The case for replacing Davis Besse with efficiency improvements and renewable energy sources

Davis Besse re-licensing community hearing
St. Mark's Episcopal Church, Toledo, OH
December 18, 2010

Errors in the First Energy Environmental Report (Appendix E):

Notes from Davis Besse re-licensing community hearing

Average Daily Solar Radiation 1961-1990

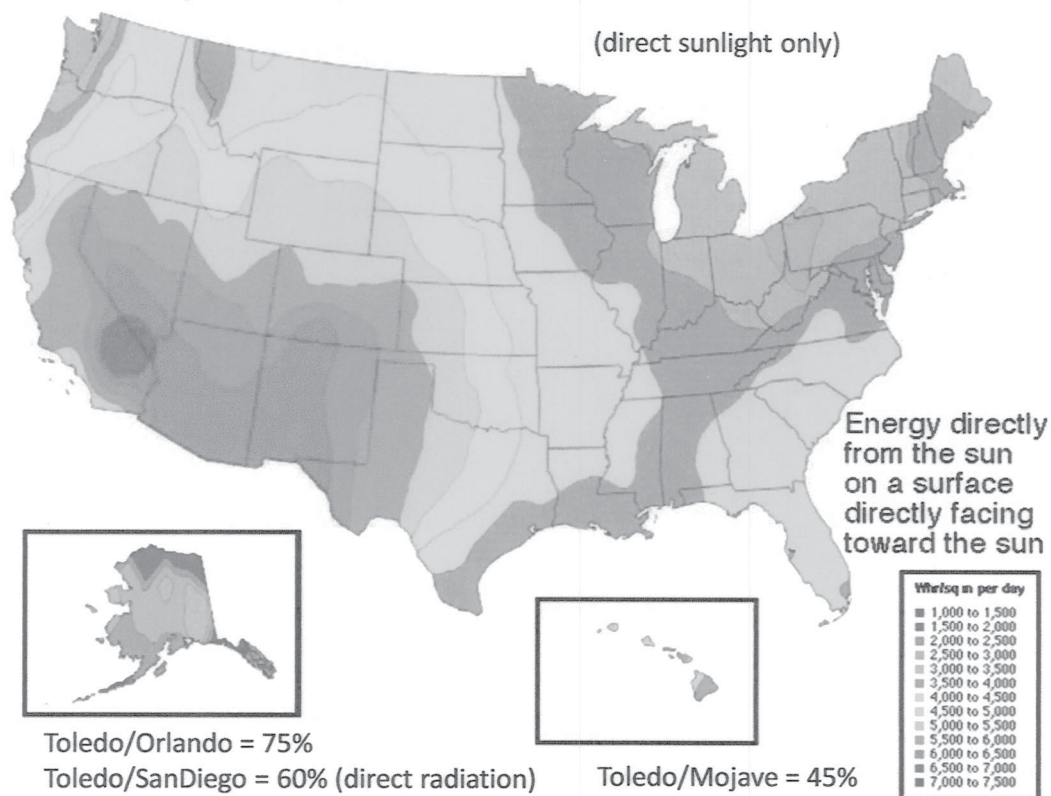
- must consider full-sky insolation, not just direct solar
- must use current costs and cost projections for PV, not data from 1998!
